# Access Compliance Report

## Public Rights-of-Way

Intersection ID: 13057	Main Street: E_MOREHEAD_ST	Cross Street: S_COLLEGE_ST	Location: NE
ADA ID: 773A63A9378A	Ramp Type: PerpDiag	Initial Pass/Fail: Fail	Overall Compliance: No
Codes/Mitigation Info/Possible Solution		Field Measurements/Component Compliance	
Severity Score: 43.75

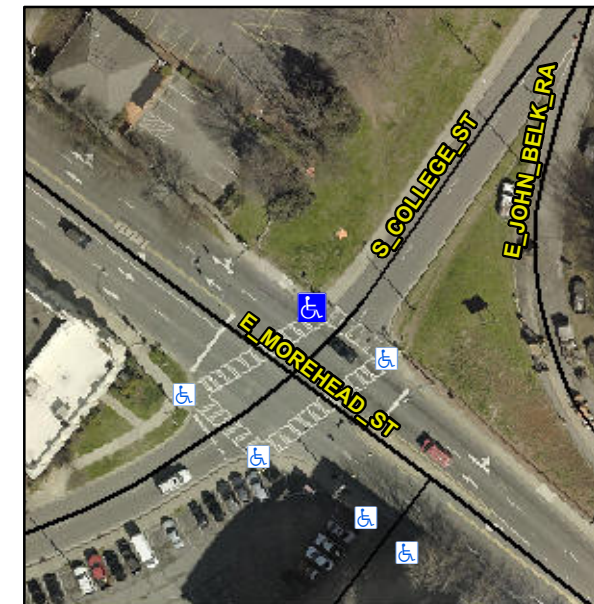
**Not Found, R304.5.1, R304.2.2, R304.5.3**

Compliance	Description	Data	Compliance	Description	Data
N/A	Ramp Length (in)	60.0	No	Ramp Slope (%)	12.6
No	Ramp Width (in)	34.0	No	Ramp XSlope (%)	3.2
N/A	Flare Type LT	N/A	N/A	Flare Type RT	N/A
N/A	Flare Slope LT (%)	N/A	N/A	Flare Slope RT (%)	N/A
N/A	Flare Traversable LT?	N/A	N/A	Flare Traversable RT?	N/A
N/A	Landing Length (in)	N/A	N/A	DWS Provided?	N/A
N/A	Landing Width (in)	N/A	N/A	DWS Contrast?	N/A
N/A	Landing Slope (%)	N/A	N/A	DWS Length (in)	N/A
N/A	Landing X Slope (%)	N/A	N/A	DWS Full Width?	N/A
N/A	Landing Curb? (Y/N)	N/A	N/A	DWS Offset (in)	N/A
N/A	Shared Landing?	N/A			
N/A	Gutter Ponding?	N/A	N/A	Gutter Slope (%)	N/A
N/A	Gutter Lip Ht (in)	N/A	N/A	Gutter X Slope (%)	N/A
N/A	Painted X Walk1?	Yes	N/A	Painted X Walk2?	Yes
	X Walk 1 Direction	To SW		X Walk 2 Direction	To SE
N/A	X Walk 1 Width (in)	101.0	N/A	X Walk 2 Width (in)	103.0
	X Walk 1 Slope (%)	2.9		X Walk 2 Slope (%)	2.4
	X Walk 1 X Slope (%)	2.9		X Walk 2 X Slope (%)	0.1

N/A	Ramp inside XWalk1?	Yes	N/A	Ramp inside XWalk2?	Yes
	Road Slope (%)	1.4	N/A	Clear Space?	N/A
	Road X Slope (%)	1.8	N/A	Clear Space to XWalk (in)	N/A
N/A	Any Obstructions?	N/A	N/A	Storm Grate/Utility Hazard?	N/A
	Obstruction Type			Storm Grate/Utility Type	
		N/A			N/A
		Yes		Surface Condition? (G/P)	Good

**Remove & Replace Curb Ramp With Two New Directional Ramps or Equivalent.**
